Re: Village of Hoffman Estates
Village Green Concessions
Architect's Project Number: 24-002
Addendum #3

ADDENDUM #3

September 27, 2024

ELECTRICAL LIGHTING PLAN
 ADDENDUM #3

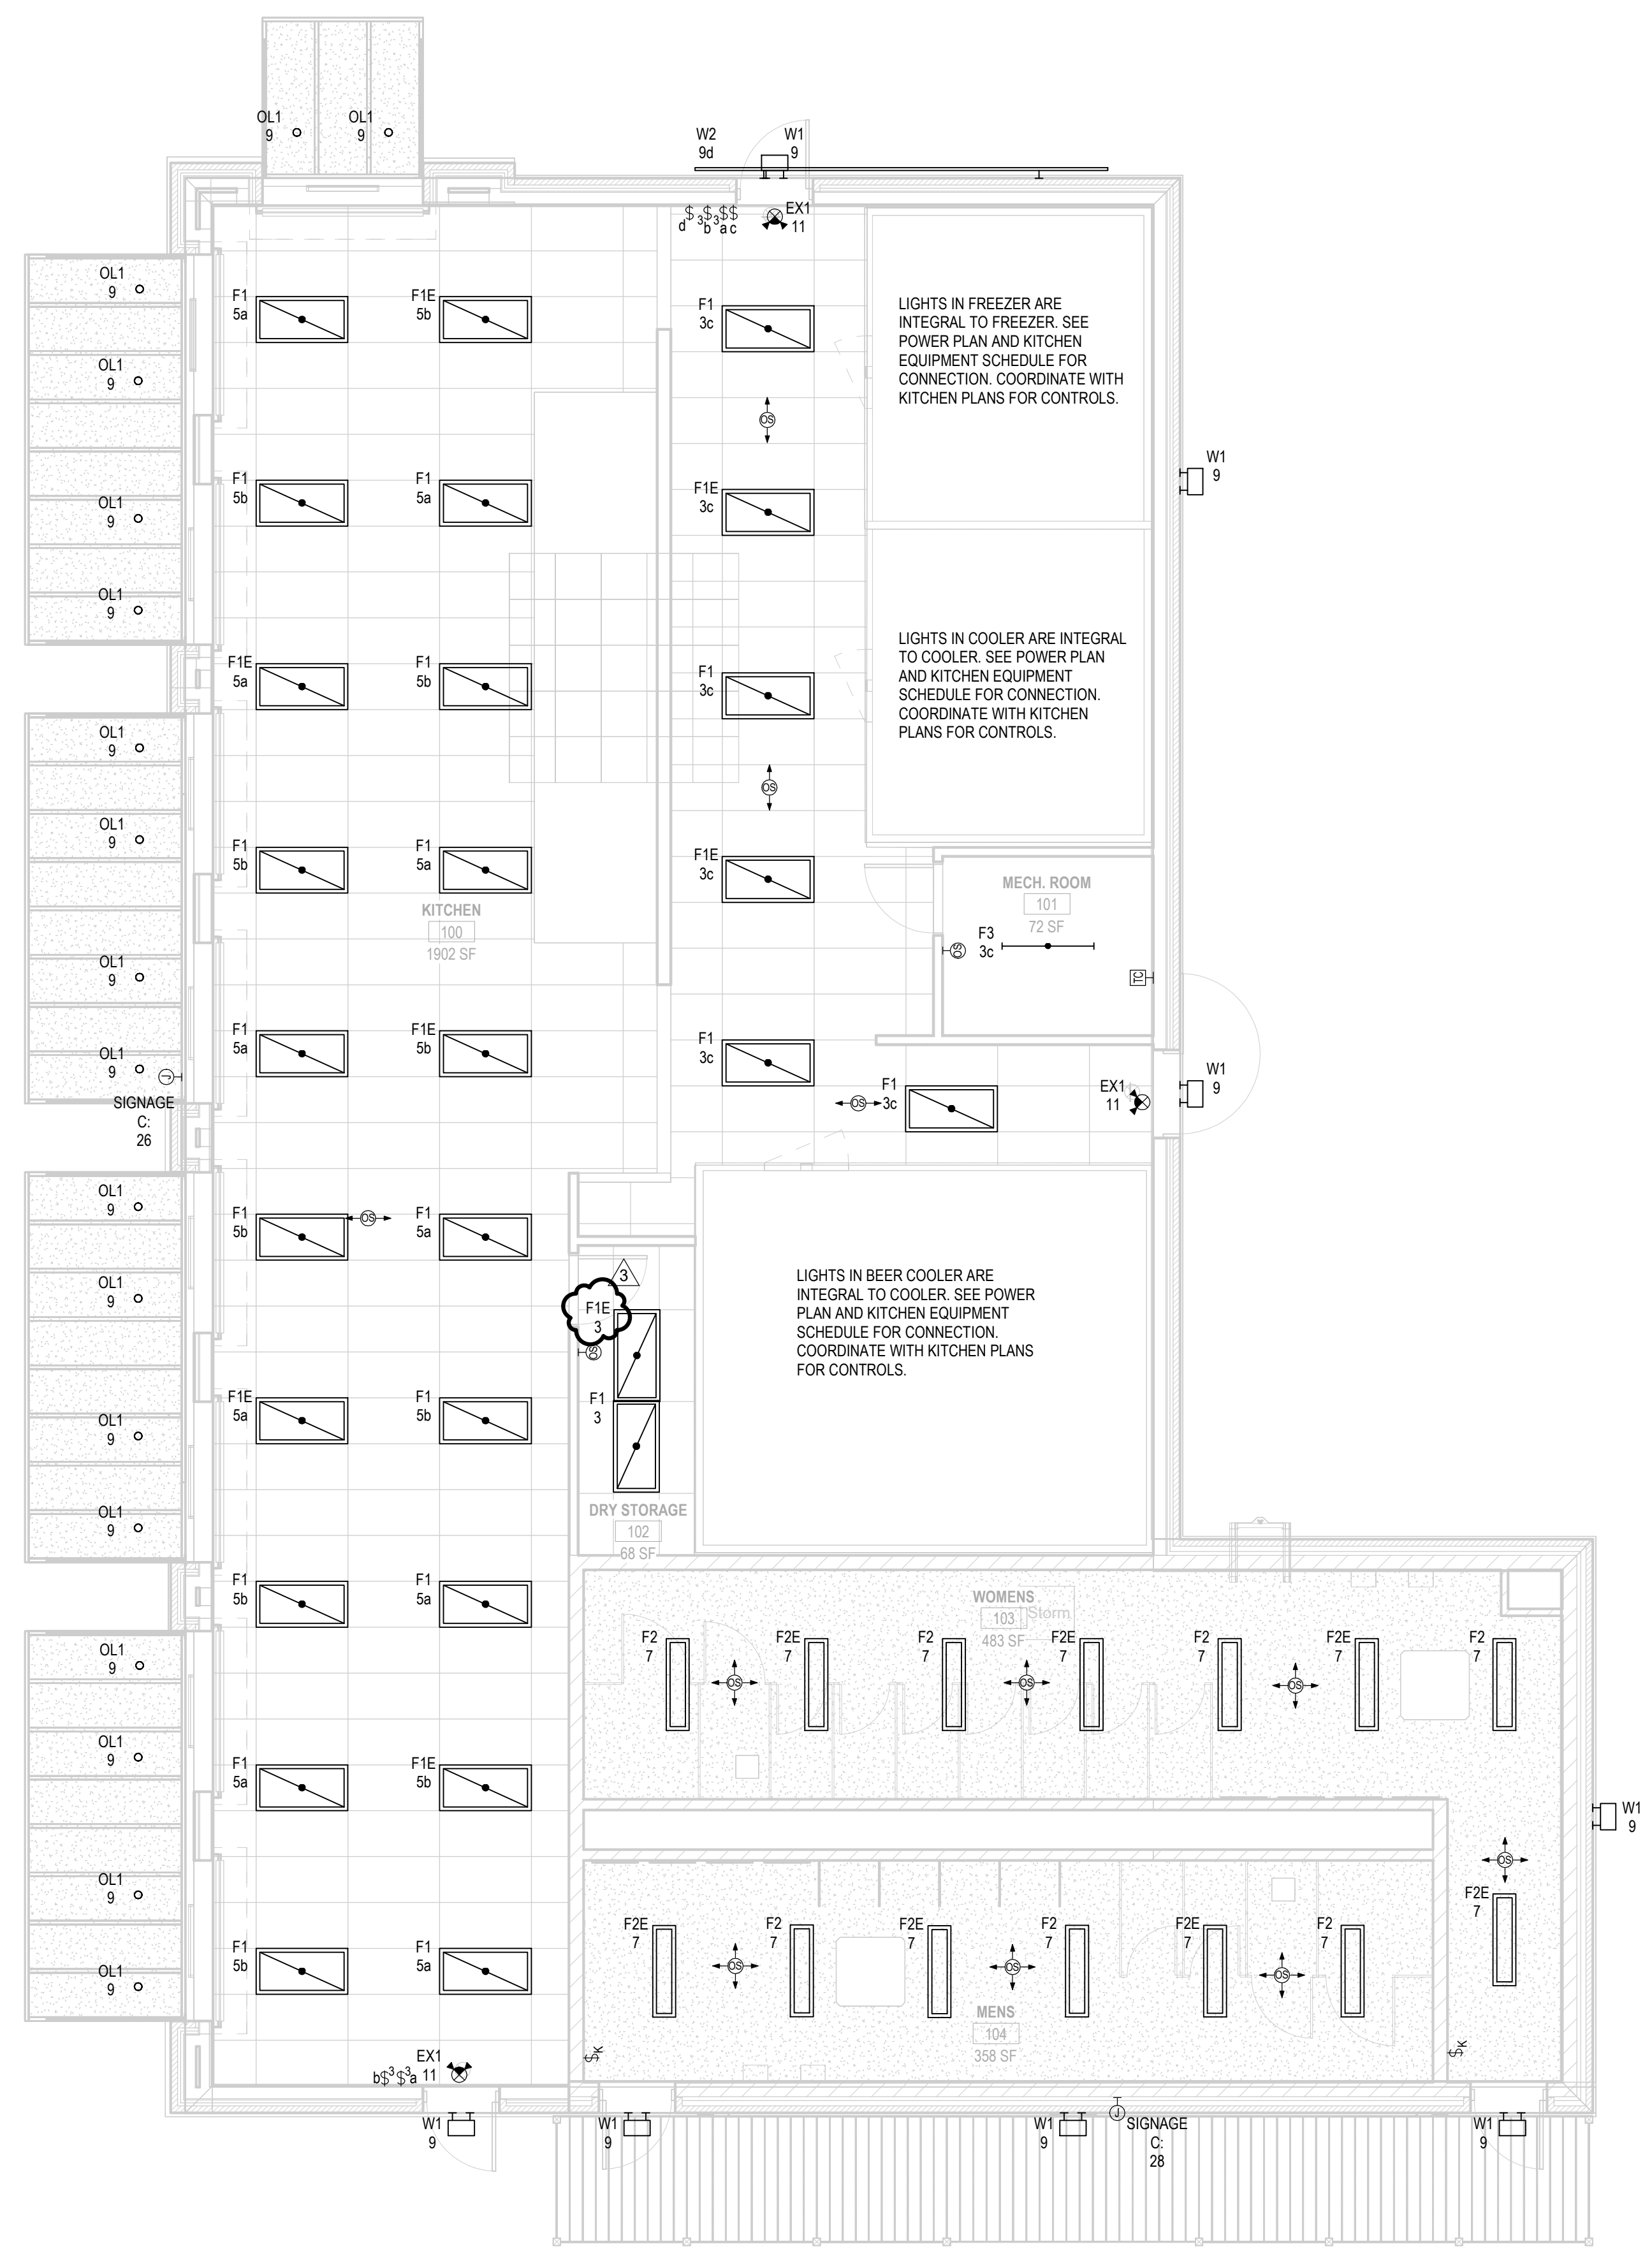
10. Drawing E2.00 – **REPLACE** with attached E2.00 to revise as follows:
 - a. Replace one F1 fixture type in Dry Storage 102 with F1E fixture type.
11. Drawing E4.00 – **REPLACE** with attached E4.00 to revise as follows:

- a. Panel 'B' circuits under exhaust hood to include spaces for shunt trip breakers.
 - b. Move indicated POS circuits from Panel 'B' to Panel 'C'.
12. Drawing E5.01:
